The Commission has issued the enclosed Amendments Nos. 24 and 21 to Facility Licenses Nos. DPR-33 and DPR052, respectively, for the Browns Ferry Nuclear Plant, Units Nos. 1 and 2.

BROWNS FERRY NUCLEAR PLANT UNIT NO. 1

BROWNS FERRY NUCLEAR PLANT UNIT NO. 2

ATTACHMENT TO LICENSE AMENDMENT NO. 24 TO DPR-33

Figure 4.8-1

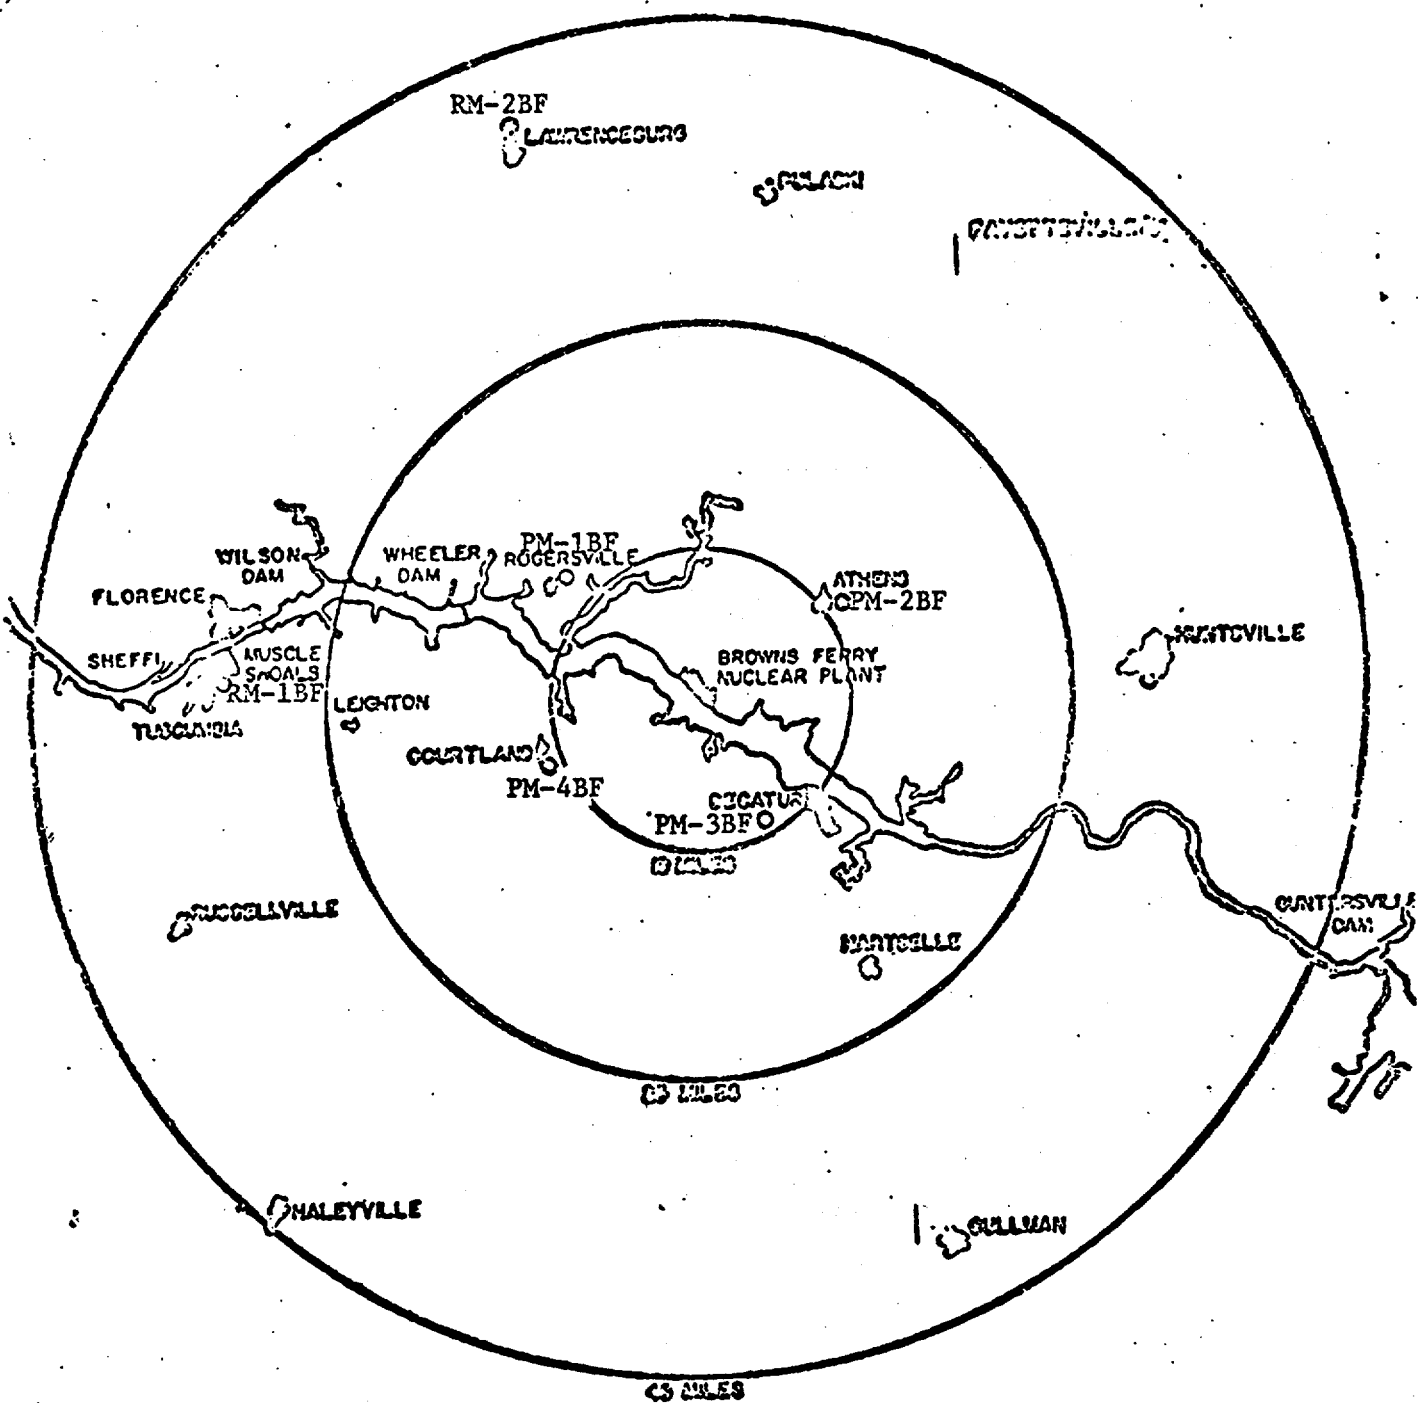
These amendments change the provisions in the Technical Specifications to revise the network of remote atmospheric monitoring stations to conform with the network as approved by the Commission for Unit No. 3. They permit the relocation of two remote air monitors from distant location, 45 miles from the facility. One of these monitors will be relocated to the site boundary of the facility, and the other will be available as a stand-by for any of the eleven remote air monitors which becomes inoperable. Monitoring at distances of about 45 miles from the plant is adequately provided by two other distant remote air monitoring stations.

These amendments change the provisions in the Technical Specifications to revise the network of remote atmospheric monitoring stations to conform with the network as approved by the Commission for Unit No. 3.

- a. The atmospheric monitoring network is divided into three subgroups consisting of 11 monitoring stations. The monitoring stations are shown on Figures 4.8-1 and 4.8-1a. These monitoring locations are subject to change dependent upon continued evaluation of the environmental monitoring program. The station at Muscle Shoals will be used as background reference.
